file location: S:\7068 DoE\7068WA01 North Sydney Public School Upgrade\02 DRAWINGS\1. ArchiCAD Files\7068WA01 - North Sydney Public School Upgrade - SD Archive 1 SEC 4.55 MOD 3.pln

SEC. 4.55 MODIFICATION (NO. 3) ITEMS

Application No: SSD-11869481-Mod-3 Granted: 22 December 2023

- NORTH SYDNEY PUBLIC
- SCHOOL

BUILDING I & J - ELEVATION 02

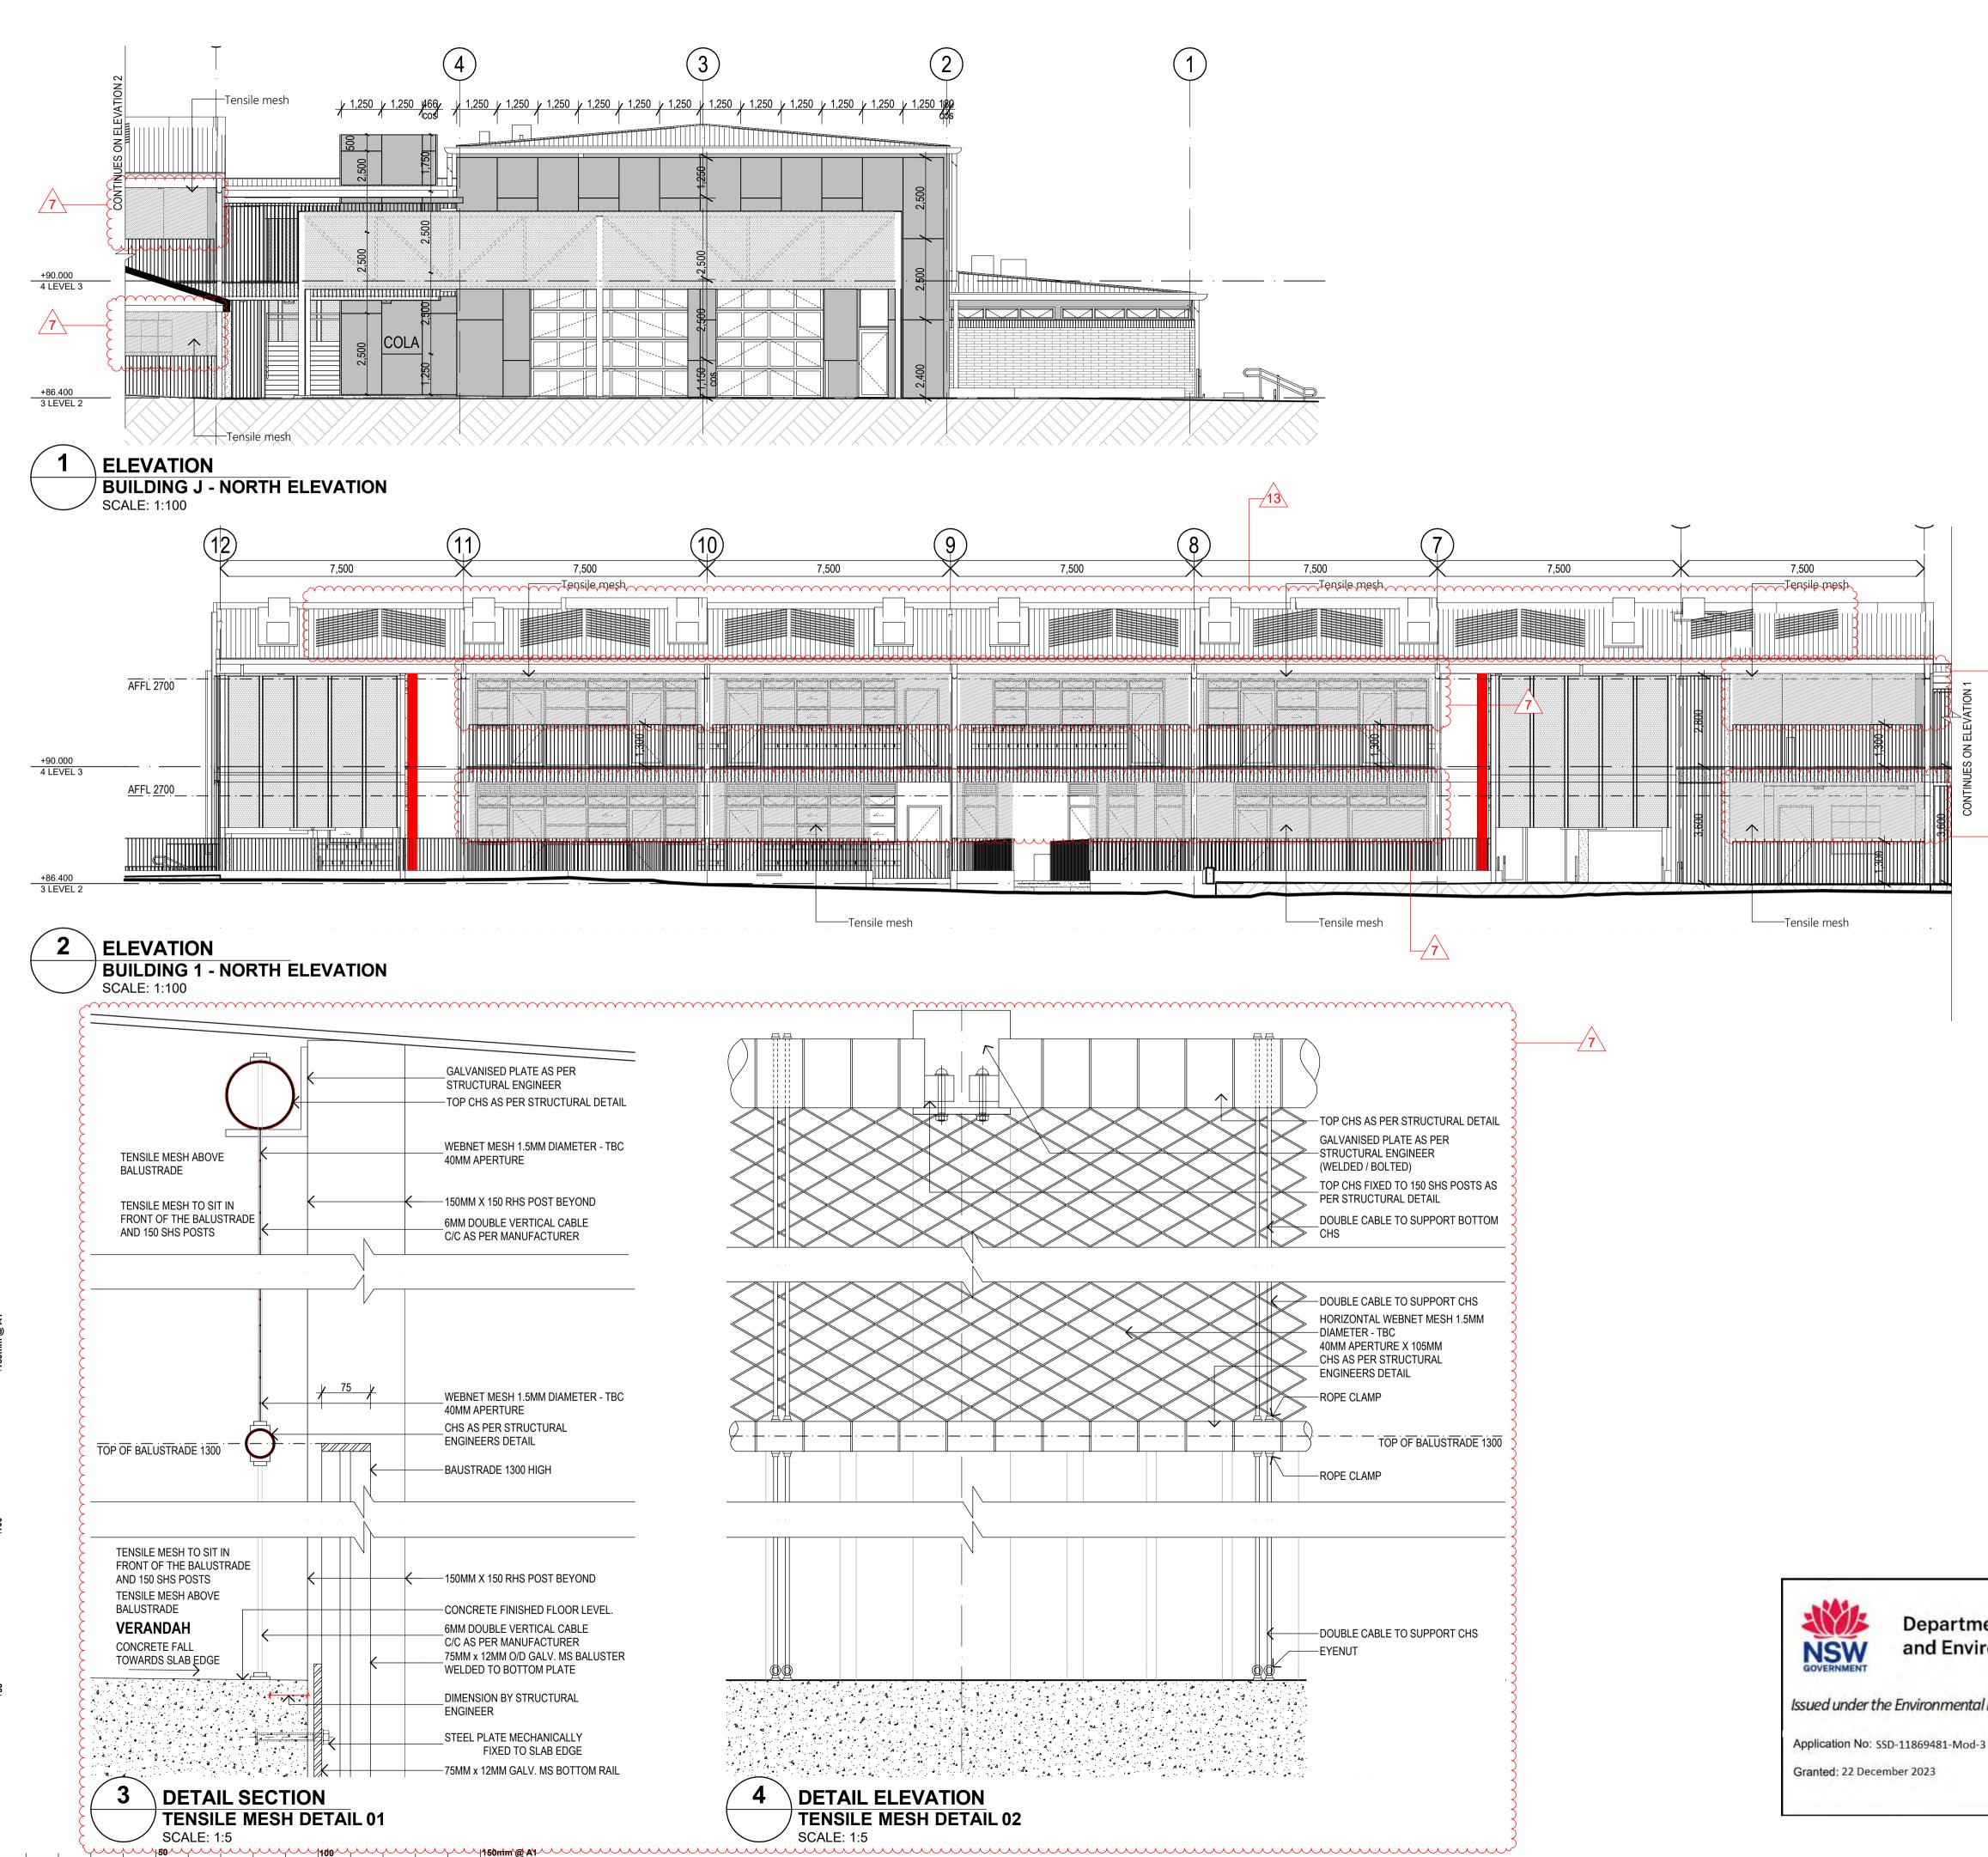
This drawing shows design features and elements of a design prepared by Fulton Trotter Architects and is to be used only for work authorised in writing by the designers. It cannot be copied directly or indirectly, in whole or in part, nor shall it be used for any other building purposes. Unauthorised use will be considered an infringement of these rights. **ELEVATION LEGEND** PRECAST GRC PANEL PREFINISHED CFC CLADDING METAL FASCIA / GUTTER BRICKWORK METAL SCREENING SEC. 4.55 MODIFICATION (NO. 3) ITEMS LANDSCAPE CHANGES (NEW LOCATION OF YARNING CIRCLE) LANDSCAPE CHANGES (LOCATION OF BIKE PARKING) CHANGE TO BLEACHER RETAINING WALL TO ACCOMODATE EXISTING SHADE SAIL FOOTING 4 LANDSCAPE CHANGES (PLAY EQUIPMENT) LANDSCAPE CHANGES (TIMBER DECKING) NEW ALUM WINDOWS TO MULTIPURPOSE ROOMS. 1650MM WINDOW HEIGHT WITH SILLS AT 750MM AFFL. TENSILE MESH ABOVE 1300 AFFL TO UNDERSIDE OF SLAB/ROOF CHANGES TO THE CONFIGURATION OF STAIR 08 LANDSCAPE CHANGES (2 STAINLESS STEEL BENCHES ON PLAYGROUND WEST OF BUILDING J) 10 LANDSCAPE CHANGES (WHALE LINE MARKING) 11 LANDSCAPE CHANGES (4 STAINLESS STEEL BENCHES ON PLAYGROUND SOUTH OF BUILDING F) 12 REPAIRS TO SECTION OF HERITAGE FENCE 13 CHANGES TO SOLAR PANELS **∕ O**`
